**ITEM 7. DEVELOPMENT APPLICATION: 148-160 KING STREET SYDNEY****FILE NO: D/2016/1160****DEVELOPMENT APPLICATION NO: D/2016/1160****SUMMARY**

**Proposal Summary:** The subject application is for demolition of the existing building, excavation and construction of a 26 storey, mixed use development. Subject to the recommended conditions the proposed development will comprise:

**Figure 23:** Proposed level 2 common room and balcony marked in dotted black line.

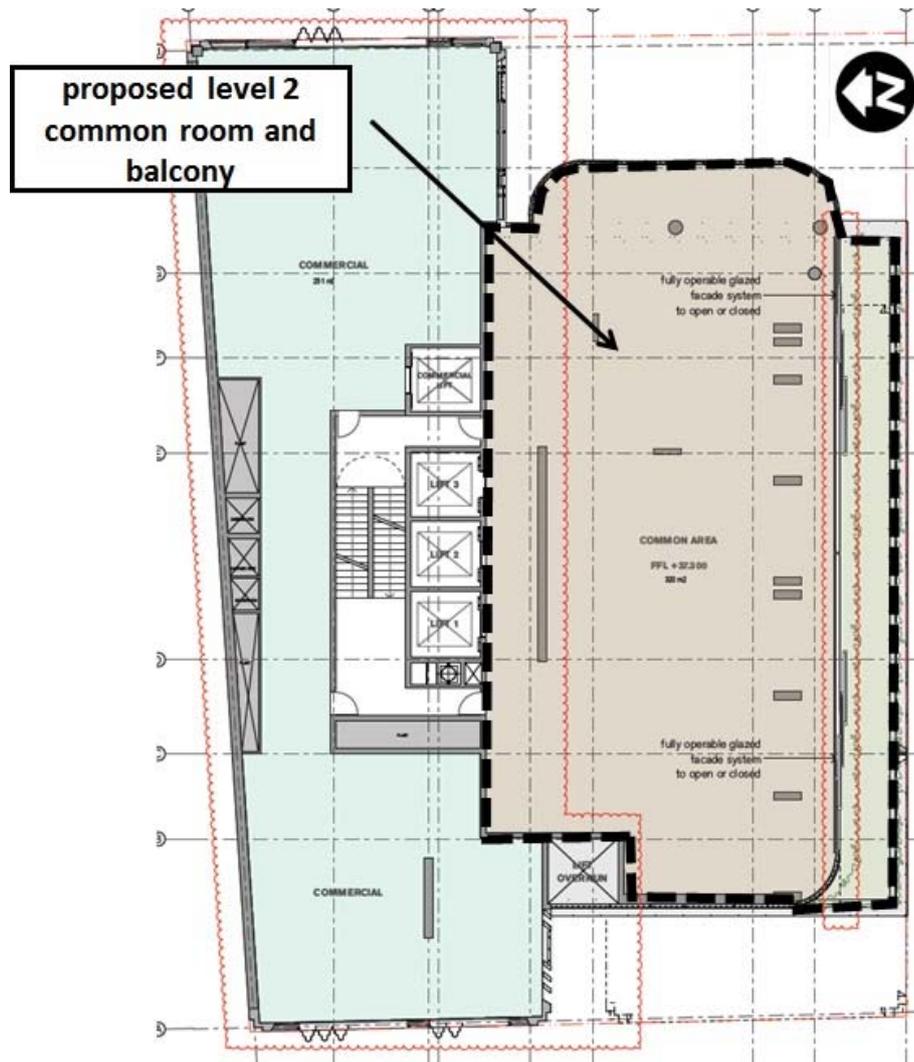
55. As shown in **Figure 23** below, the proposed development provides a common room on level 2 with an area equal to 36% (320 sqm) of site area, in lieu of a common open space.

57. The common room is located on the third storey and has a balcony atop the arched colonnade, optimising views to St James church and Hyde Park. The common room has a generous floor to ceiling height of approximately 3.6 metres and has a fully operable glazed facade system so that it can be opened or closed to provide all year round amenity.

**Figure 24:** Typical podium facade detail.

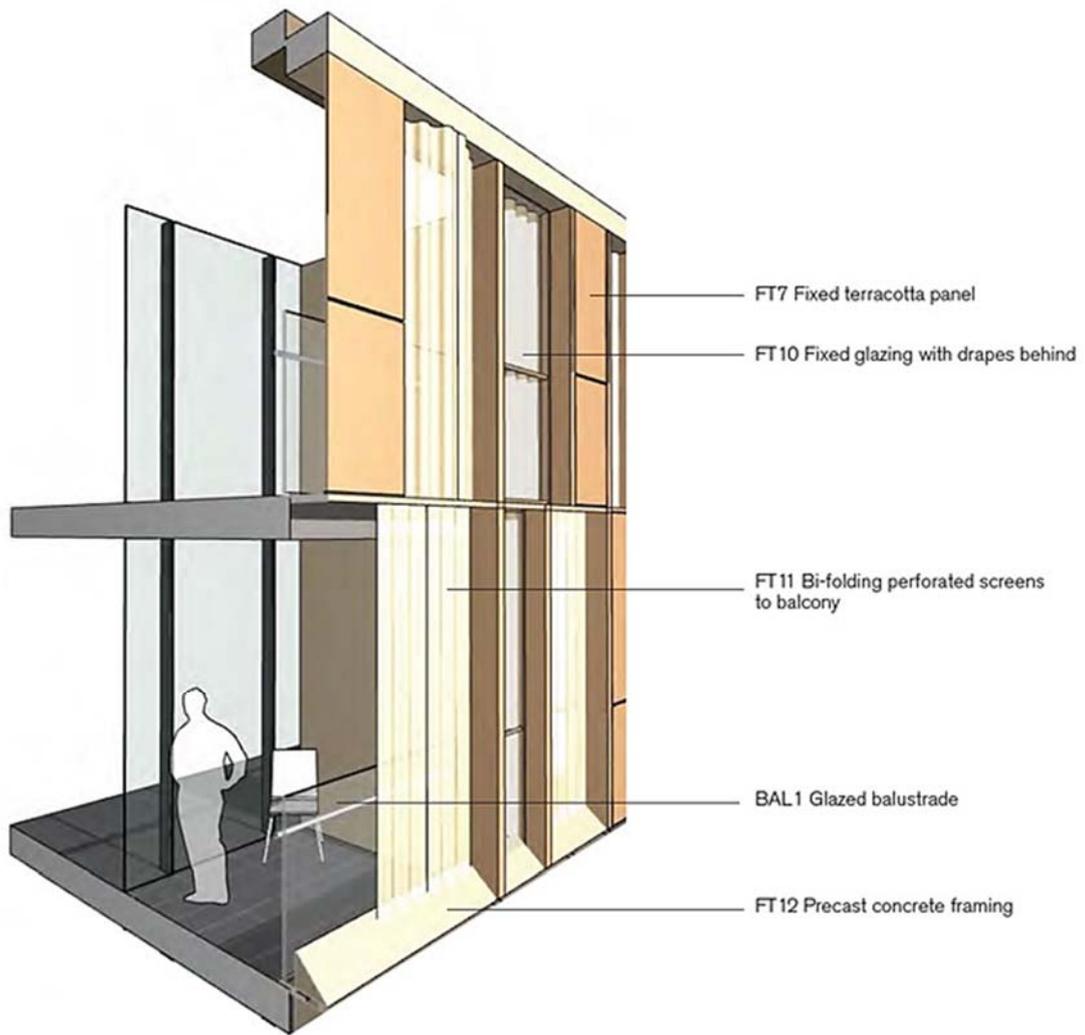
60. As proposed, the balconies within the podium currently comprise GFA. If the balconies within the podium (levels 3 to 12) were to be retained as proposed and their area attributed to GFA, they would add 735 sqm of floor area to the development. This would increase the proposed FSR from 13.58:1 (12,082 sqm GFA) to 14.40:1 (12,817 sqm GFA) and would result in a breach of the maximum permitted FSR of 13.75:1 (12,234.75 sqm GFA).

61. As a justification for variation of the FSR development standard has not been submitted, a variation cannot be considered in this instance. A deferred commencement design modification condition is recommended so that the proposed gauze clad multi-fold screens are redesigned for all the balconies within the podium (levels 3 to 12) to:
- (a) ensure that the balconies are not partly enclosed and the area of these balconies is not included in GFA;
  - (b) ensure the redesigned balconies still provide an adequate response to environmental conditions to ensure the balconies can still be used by future intended occupants; and
  - (c) which also aims to maintain the integrity of the facade design as a positive feature of the winning design scheme commented upon by the Selection Panel and noted in the report of the competitive design alternatives process.

Figure 28: Illustration of adequate separation at eastern facade of tower level 14.

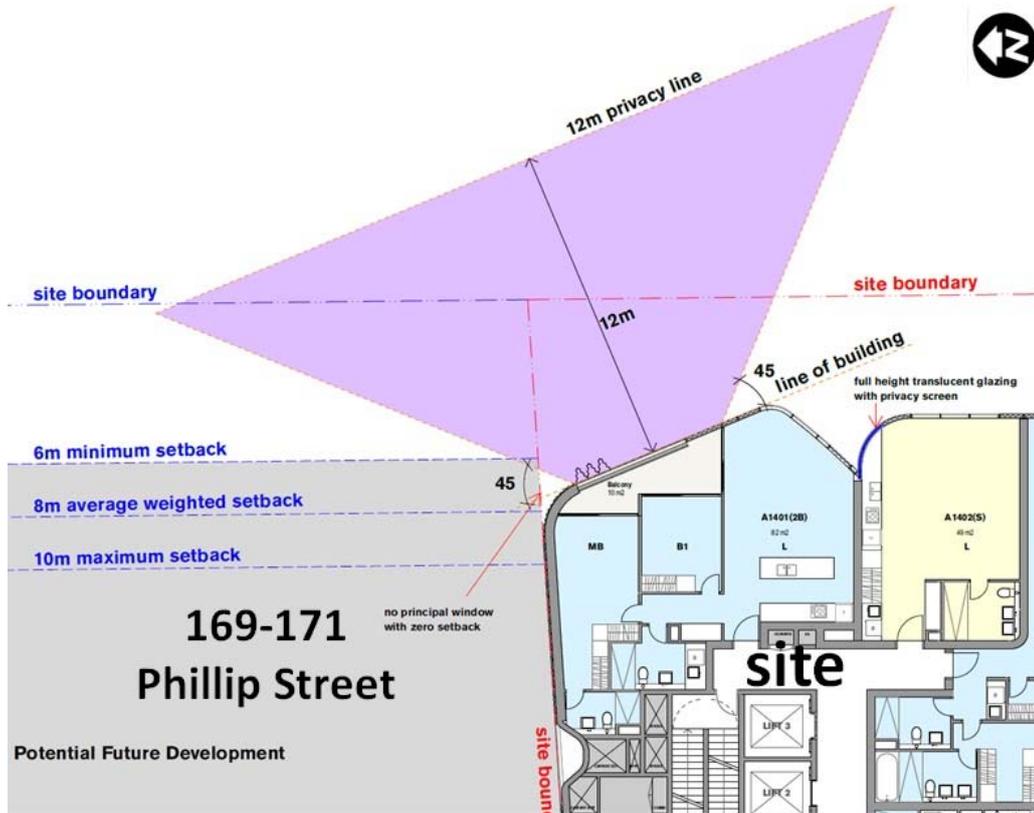
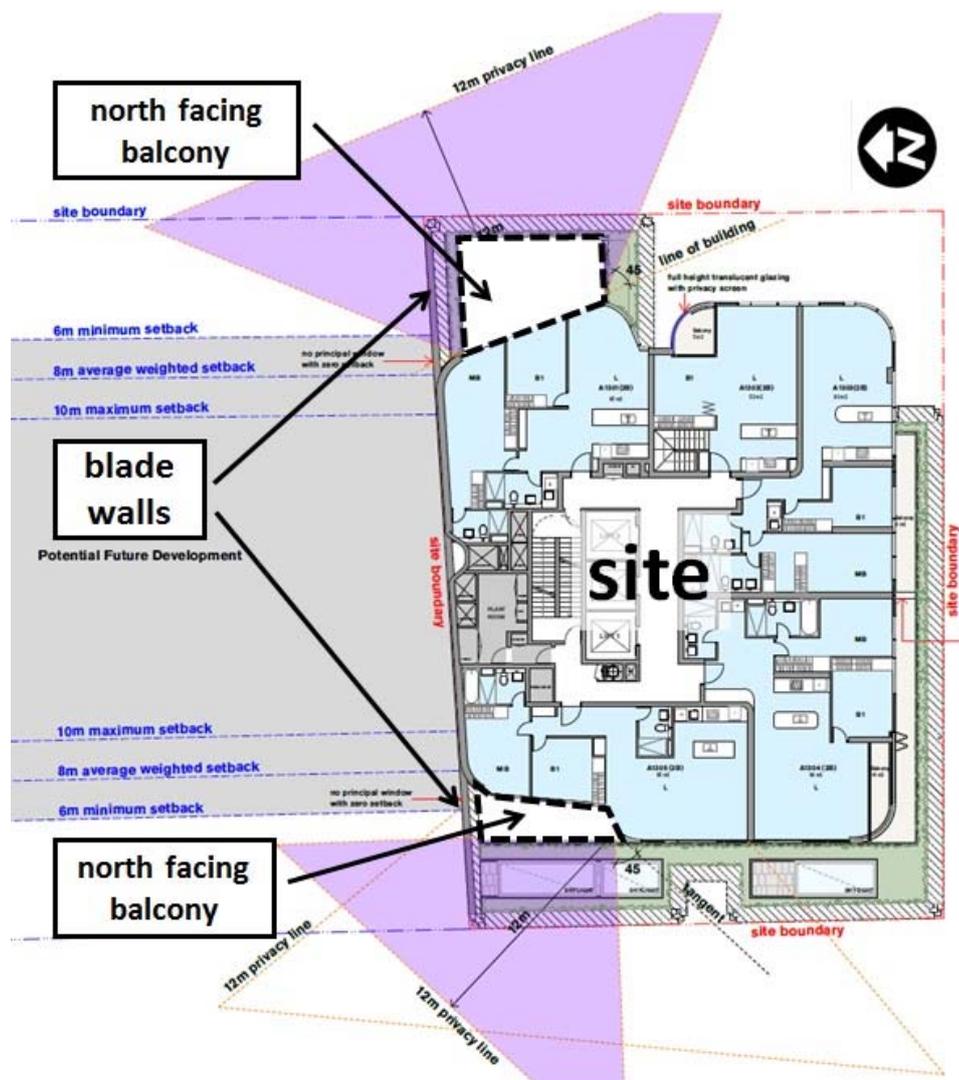
67. Concerns were raised by Council officers about inadequate setbacks and separation from the existing commercial buildings adjacent to the north at 169-171 Phillip Street and 82-88 Elizabeth Street and any potential residential/mixed use redevelopment of those sites in future.

68. The applicant’s submission in response is generally considered to be acceptable in addressing those concerns about providing adequate measures to mitigate any privacy conflicts, except for the level 13 podium-top balconies located at the north-east and north-west corners of the site as described below.

69. As shown in **Figures 28 and 29** above, by modelling a reasonably likely development footprint on the adjacent properties to the north and incorporating appropriate screening measures, it is considered that the amended proposal and supporting information has demonstrated compliance with the objectives of DCP provision 5.1.2.2 and ADG Objective 3F-1 to achieve reasonable levels of privacy for the proposed apartments and surrounding development.

Figure 34: Apartments A304-A1004 useable open space.

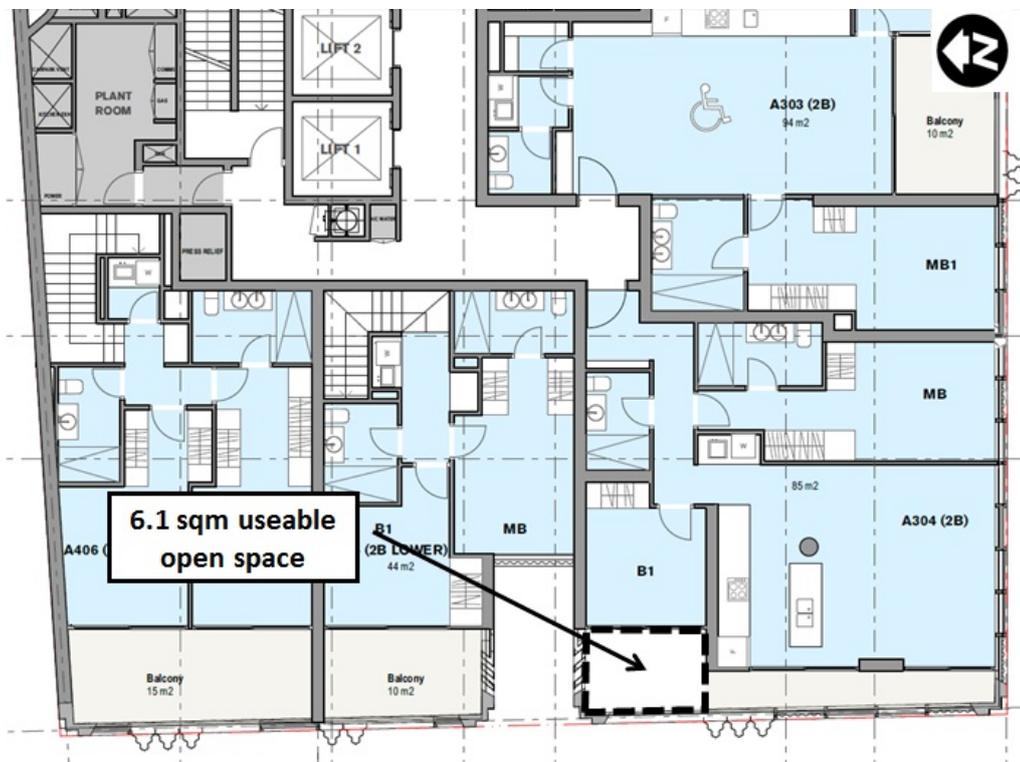
82. As shown in **Figure 34** above, 8 of these apartments' balconies (A304-A1004) contain an area of 6.1 sqm with a minimum dimension of 2m and which is considered to provide adequate useable space for outdoor seating and passive recreation and is acceptable.
83. As shown in **Figure 35** below, two (2) apartments' (A1103 and A1203) balconies contain an area of 6 sqm with a minimum dimension of 2m and which is considered to provide adequate useable space for outdoor seating and passive recreation and is acceptable.

**Figure 35:** Apartments A1103 and A1203 useable open space.

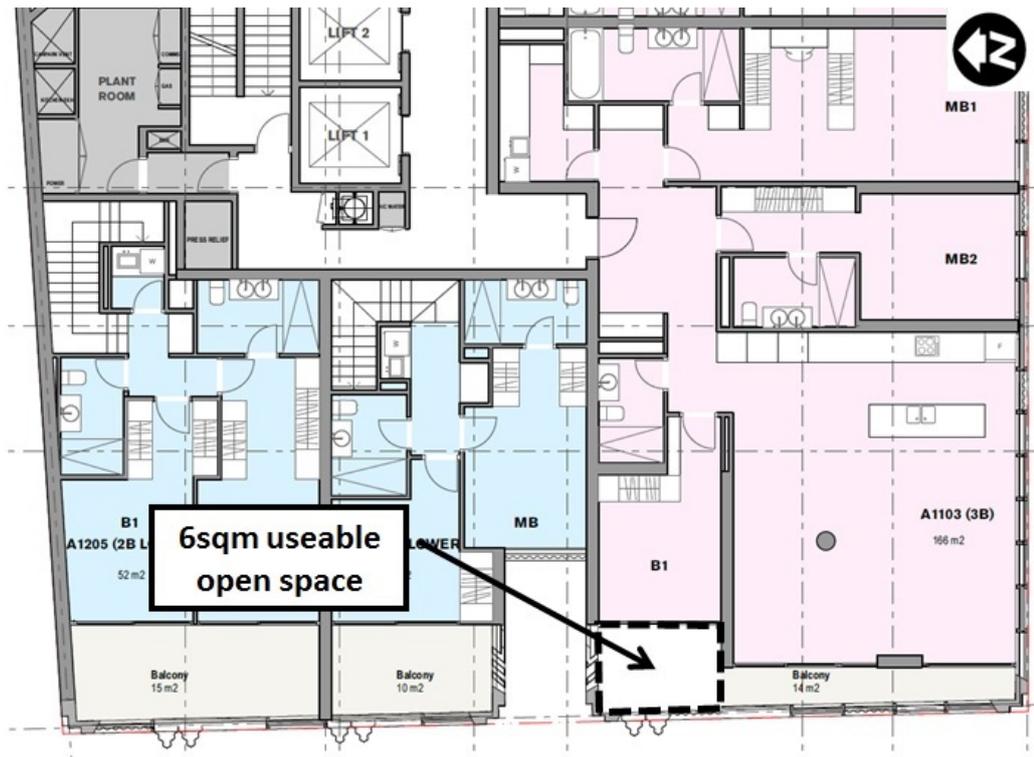
84. As noted above, apartments on level 13 are to be reconfigured to provide adequate separation and privacy. Apartment A1302 will be reconfigured in a similar fashion to A1403, only it will not incorporate a balcony recessed behind the outer facade. Despite it being reconfigured apartment A1302 will remain generously sized being 29 sqm over the ADG minimum internal size requirement and it will utilise the 8.1m long balcony adjoining its southern facade that will provide a sense of openness, light and air within the apartment. For this reason a variation to the ADG balcony minimum dimension requirements is considered to be acceptable in this instance and is supported.

Figure 36: Apartment A1401 useable open space.

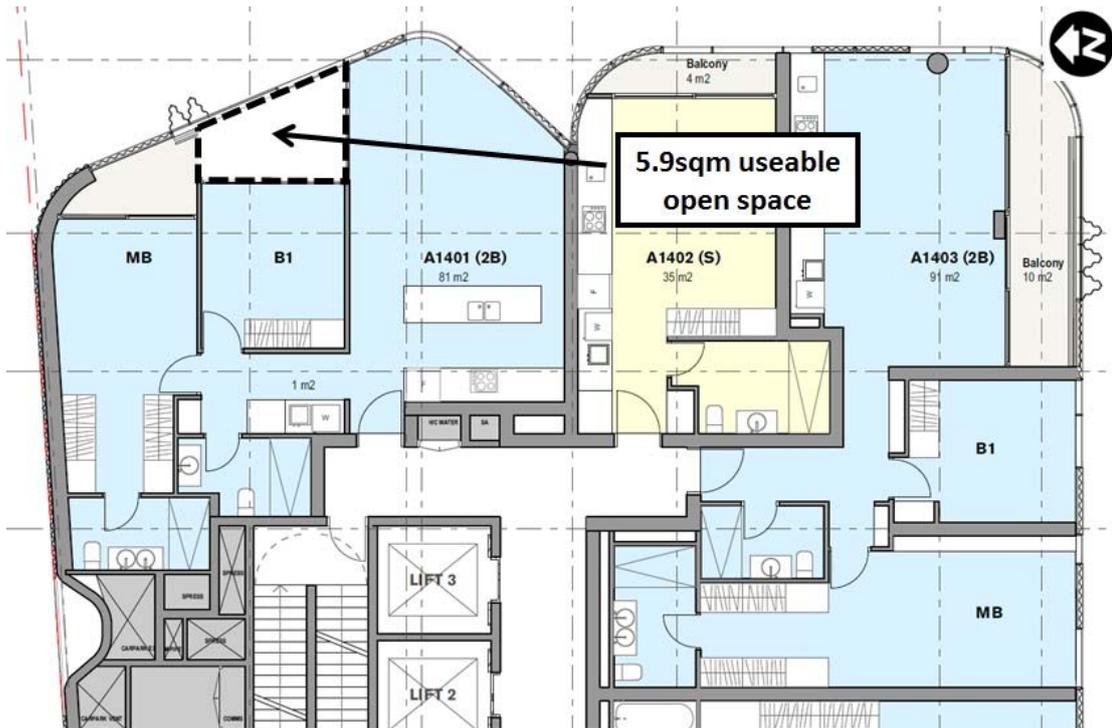
85. As shown in **Figure 36** below, apartment A1401 has a balcony that contains an area of 5.9 sqm with a minimum dimension of 2.4m and which provides adequate useable space for outdoor seating and passive recreation and is acceptable.

Figure 37: Balconies to apartments A1403, and A1504-A1804.

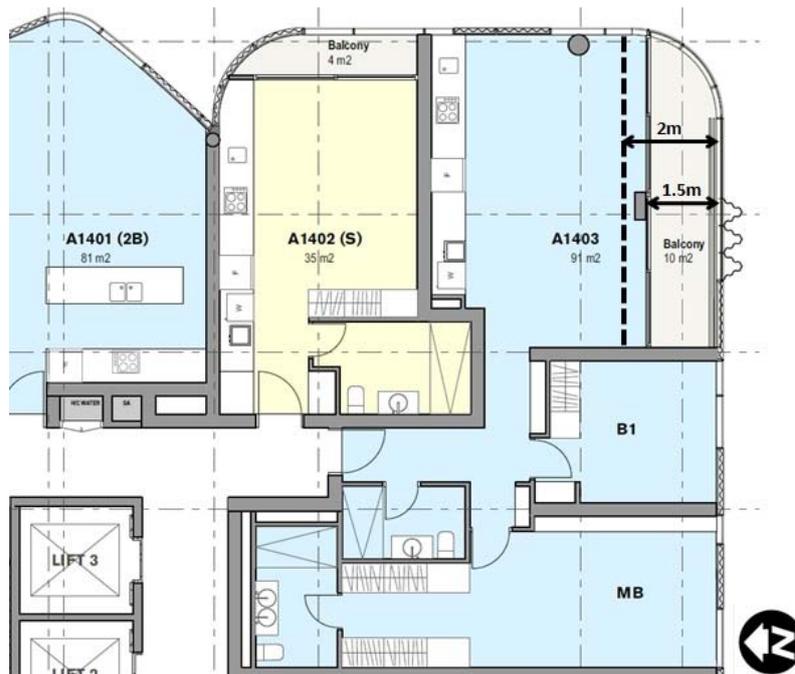
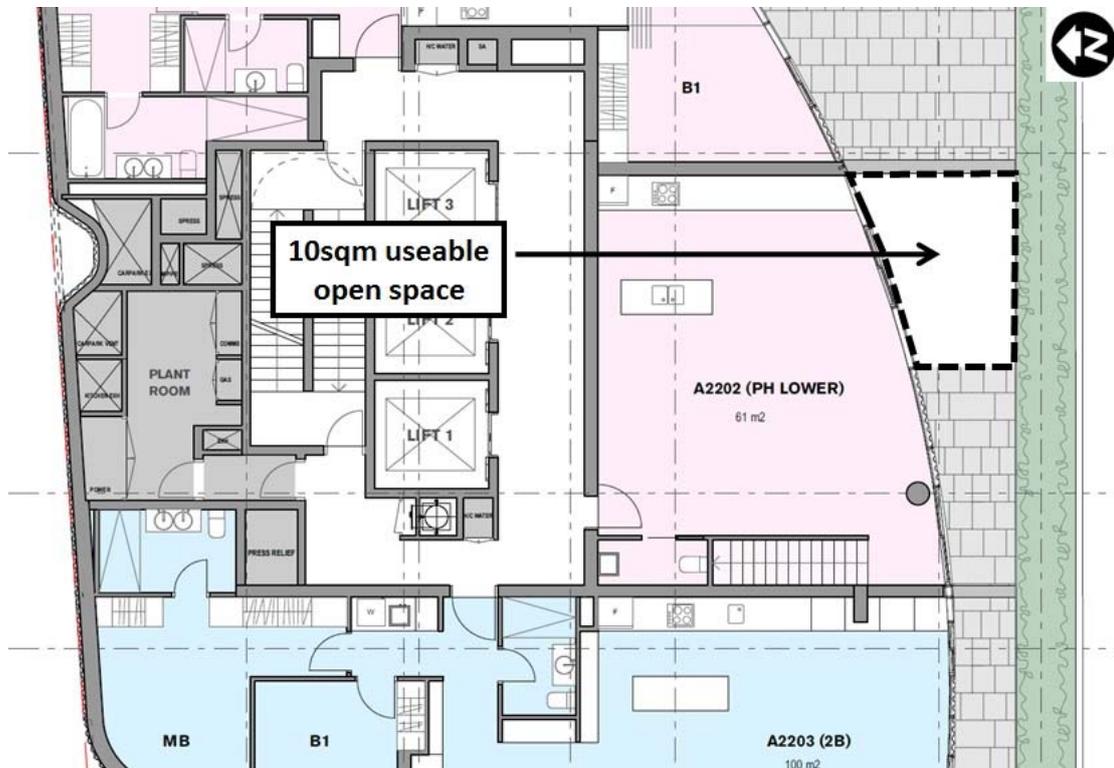
86. As shown in **Figure 37** below, 5 apartments' (A1403, and A1504-A1804) balconies are 1.5m wide and fail to achieve the minimum dimension of 2m required by ADG Objective 4E-1. If a condition to widen these balconies was imposed, it would reduce the width of the kitchen/living room. It is considered that such a condition would reduce the amenity of the kitchen/living room and would not result in the optimal configuration of indoor and outdoor spaces for these apartments. Such a condition is not recommended and a variation to the ADG minimum dimension requirements for the aforementioned apartments' balconies is supported in this instance.

**Figure 40:** Ground and first level commercial floor to floor heights.

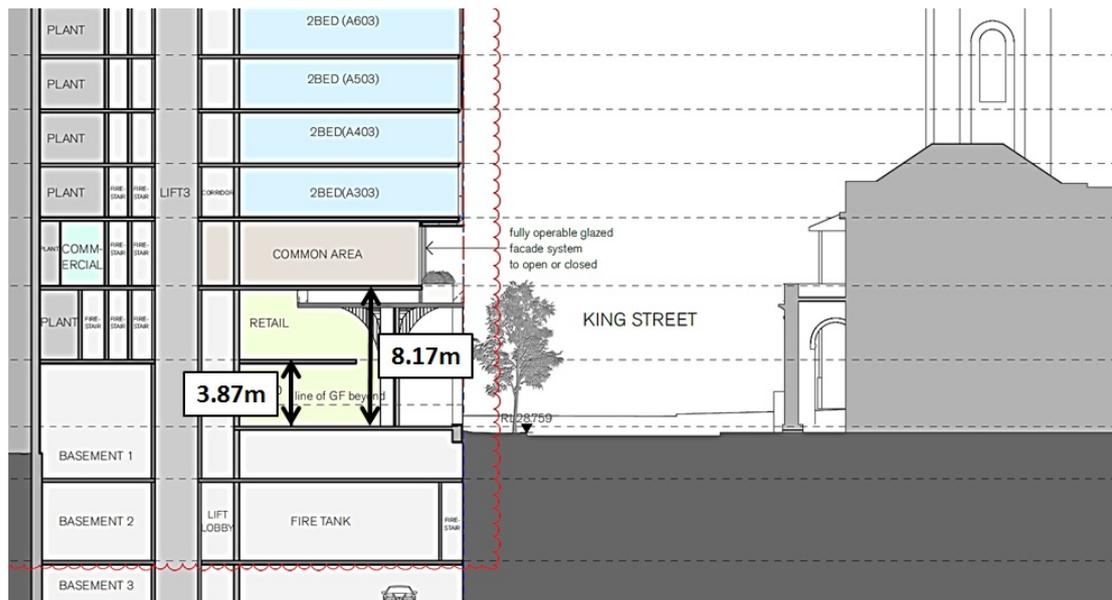
95. As shown in **Figure 40** below, the floor to floor height of the ground floor retail tenancy is 3.87m to the level 1/mezzanine, and 8.17m to the floor above (level 2) where there is a double height void for about a third of its floor area adjacent to and for the length of the King Street facade. It is considered that the proposed ground level floor to floor heights support DCP objectives to promote daylight access into and to contribute to the flexible use of buildings. For these reasons a variation to the minimum 4.5m floor to floor height requirement is supported.
